INVITATION FOR BID #17PB014
FIRE STATION #613 CONSTRUCTION
ADDENDUM #2
MAY 4, 2017

NOTICE TO ALL BIDDERS AND PLAN HOLDERS

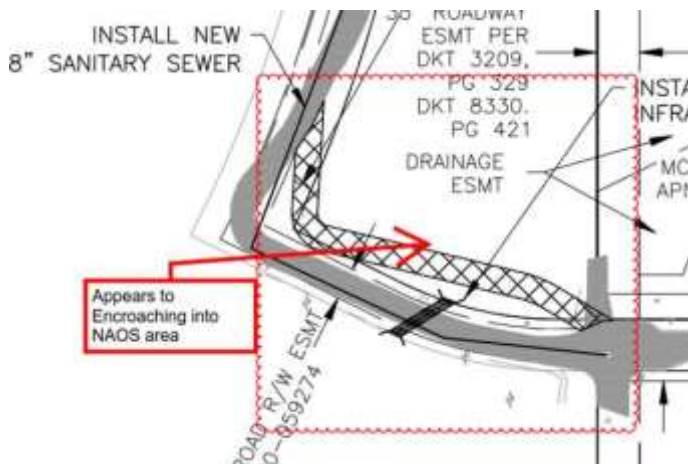
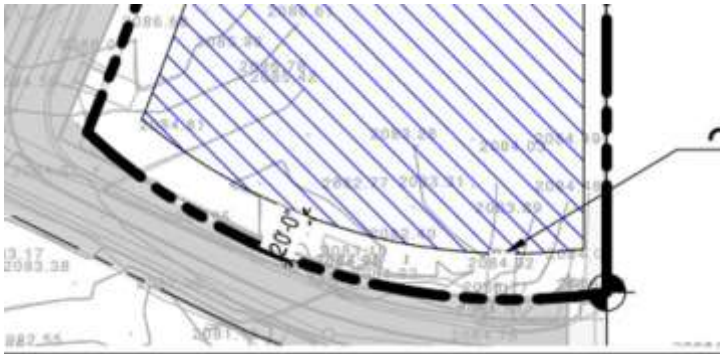
Q12 On sheet 16 of 24 on the sewer plans at station 210+70 the sewer line has less than 4 foot of cover. Has this been approved or will an alternate pipe material be required?

A12 This has been permitted by the City.
